**Third Party Verification Report
Wello Oy**

**“Penguin” Wave Energy Converter
Installation at EMEC
Wave Test Site, Billia Croo**

Document Number OP 212.001

Figure 1 Recorded Significant Wave Heights on site April and December 2017

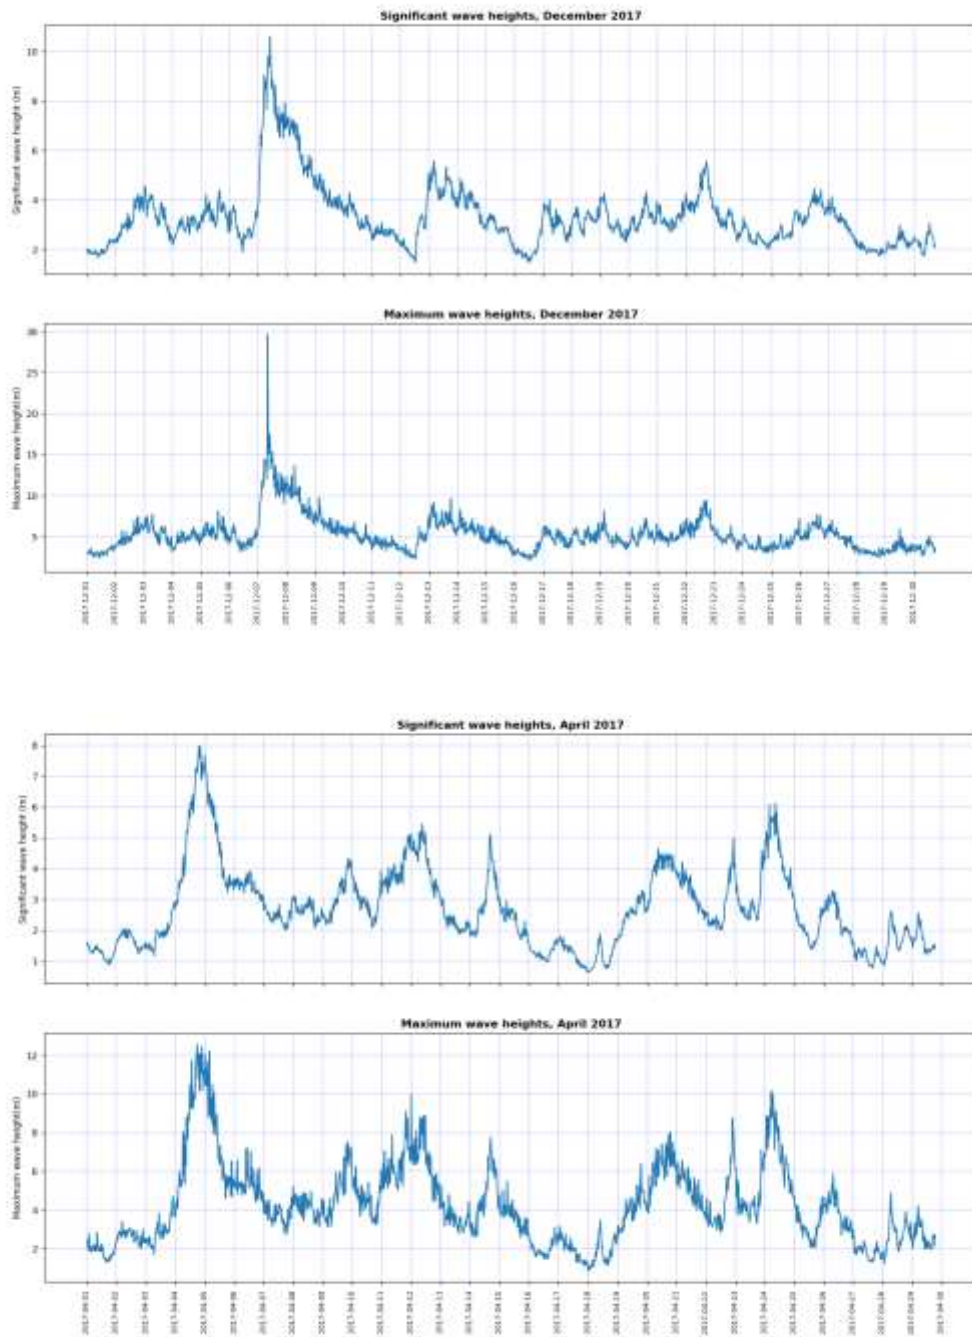
Two worst case examples of the recorded wave environment on site in 2017 and the 1 and 10 year predicted wind/wave environment used by Wello Oy are displayed below, and although the results may not be directly comparable due to limited information available, they do provide an indication of actual conditions experienced against the predicted return periods used in the mooring analysis.

Figure 3 Mooring Bracket Structural Design Differences

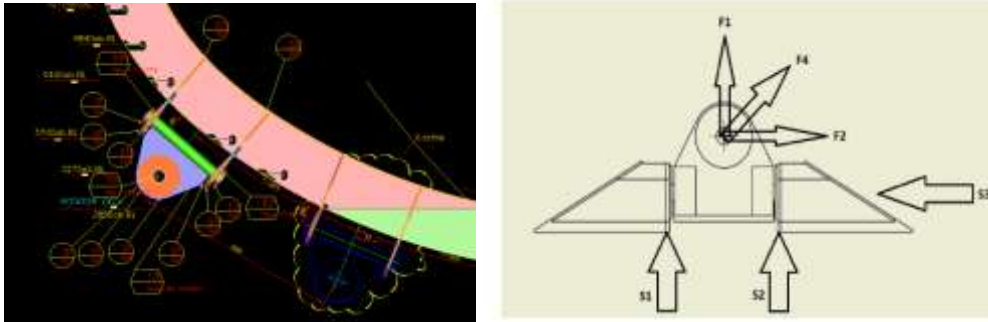
Based on the information provided it is assumed that the forward anchor brackets and the stern anchor brackets are of the same dimensions [H]. The in-house analysis [B] used 2MN (approx. 204 tonnes) as the maximum load considered and therefore all the anchor brackets are adequate in design. Although there seems to be some minor differences in hull connection design, since the main stress areas identified in [B] are around the pad eye, it is deemed acceptable for the results to be applied for all four mooring brackets. In [G], it was noted that the connection design of the mooring bracket to the hull is different from those along the centerline.

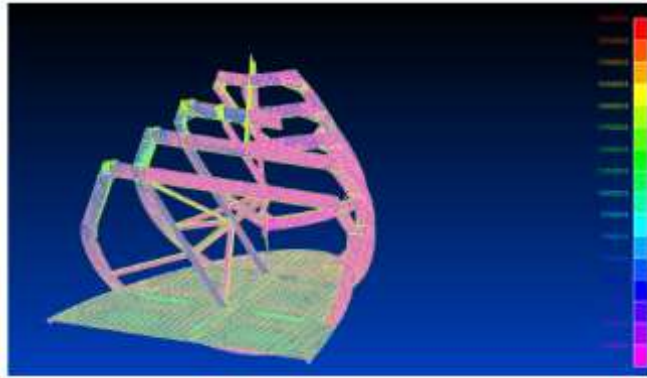
To check that the pin can resist the shear stress in this design, for double shear,

Assuming shear strength as 0.58 of tensile yield strength, shear strength is around 205.9MPa. This gives a safety factor of 3.17 in the pin, and is thus acceptable.
